Project Proposed Extension Manor House Burnham Road South Creake

Staircase Plans and Sections

Drawing No. 2486-16E

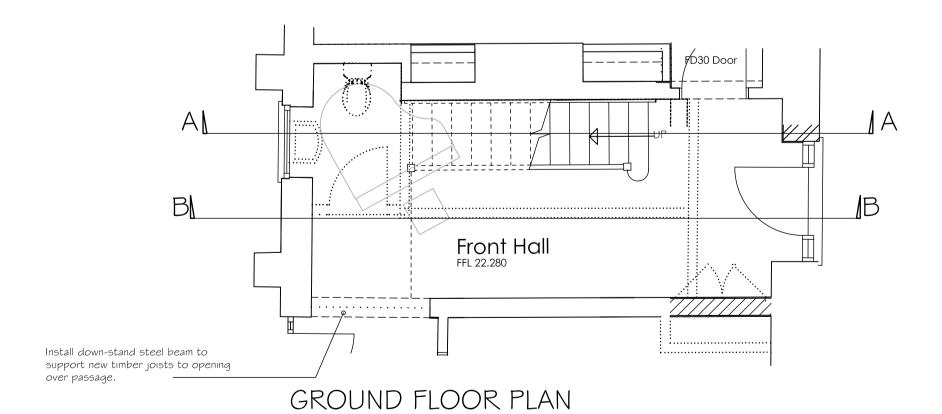
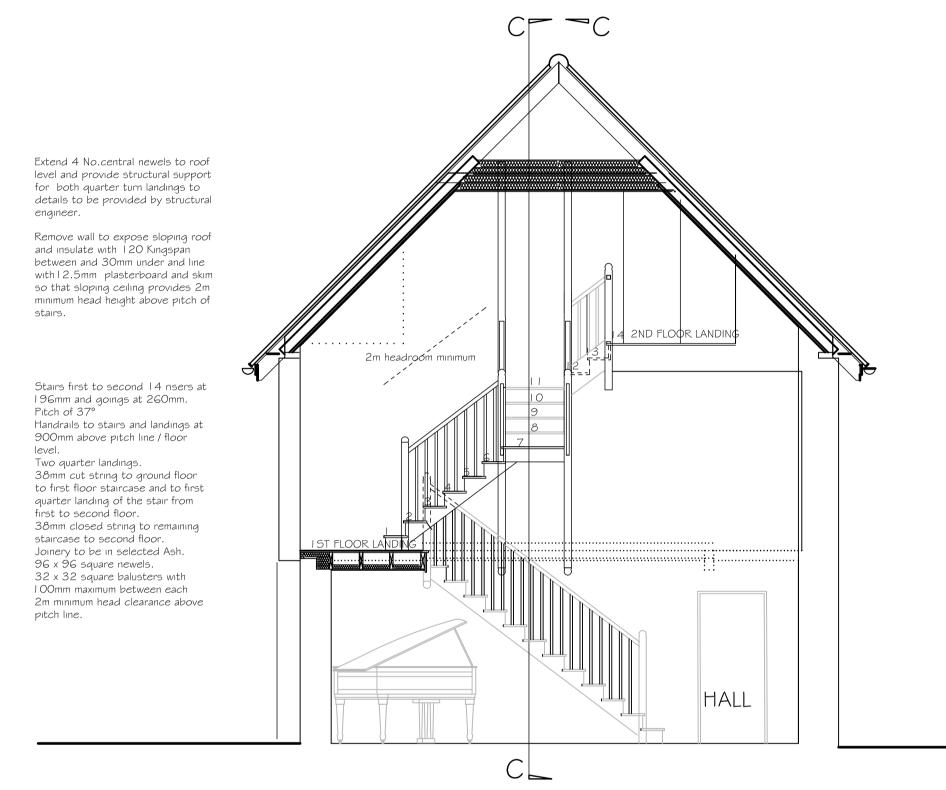
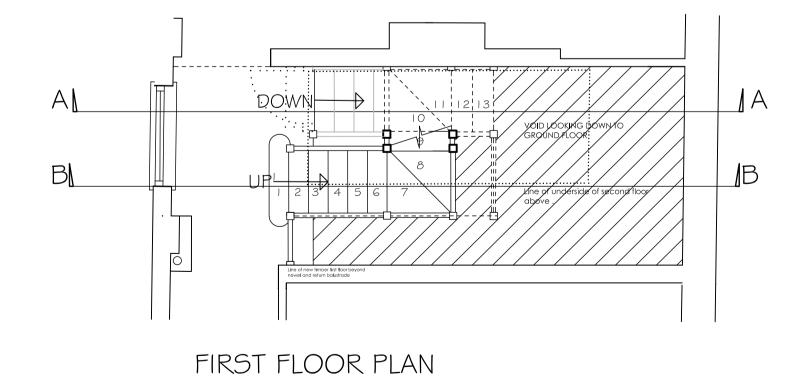
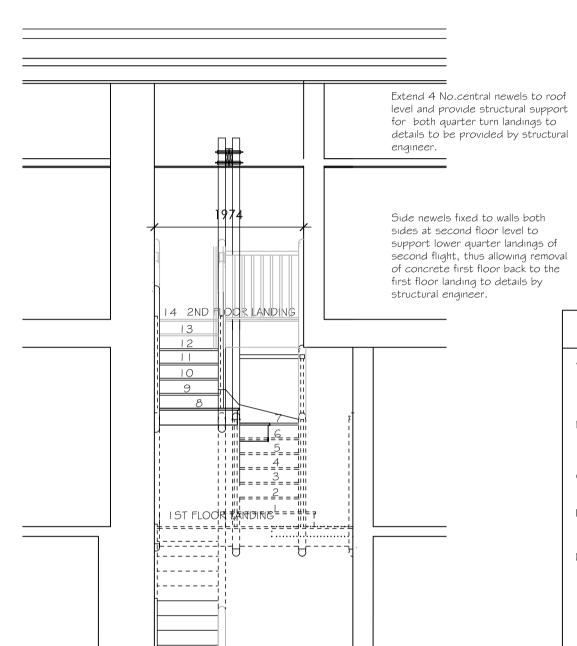
16.08.22 Staircase sections revised from two straight flights with

17.08.22 Stair design from first to second floor amended to suit

support stair first quarter landing newels.

at that level.

17.10.22 32 x 32vertical balusters added added

196 rises and 225 goings, pitch 41° to one straight

existing position of second floor wall which is fixed at

truss position including vertical 32 diameter iron rod.

Amendments made including retaining small gallery to

Whole of concrete floor at first floor over Hall shown completely removed with new timber floor forming passage

flight and one with two quarter landing turns with 196rises and 260mm goings pitch 37°.
